Product Awareness Notice 06001 Version 1.0 Date 1/02/2006 Page 1 of 2

Products affected Datatenna Transmitter
Datatenna Repeater
RDC Transmitter
RDC Repeater

Old style serial number

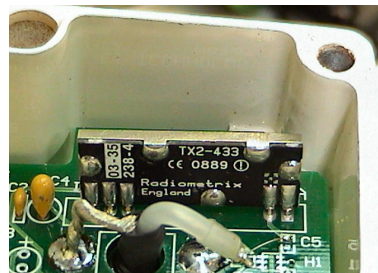
While there is no defined cut off point for the old version, a general rule of thumb is that units below serial number 28450, or without a barcoded number should be fitted with the old radio. Any barcoded units should be fitted with the high power Genesis module.

Low power Radiometrix module

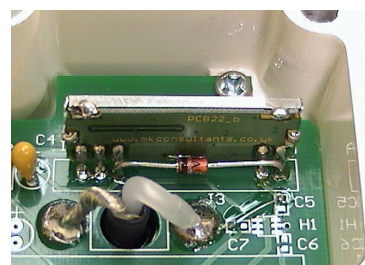
Prior to December 2004, EIT used a 10mW Radiometrix transmitter chip in Datatennas and RDC units. These radios were capable of transmitting about 1km in good line-of-sight conditions.

Subsequent to that time, the chip was upgraded to a 25mw Genesis GT1. The latter has vastly increased range, up to 4km in good line-of-sight conditions.

If uncertainty exists, it is possible to identify the chip by unscrewing the

Datantenna or RDC base and checking the chip visually.
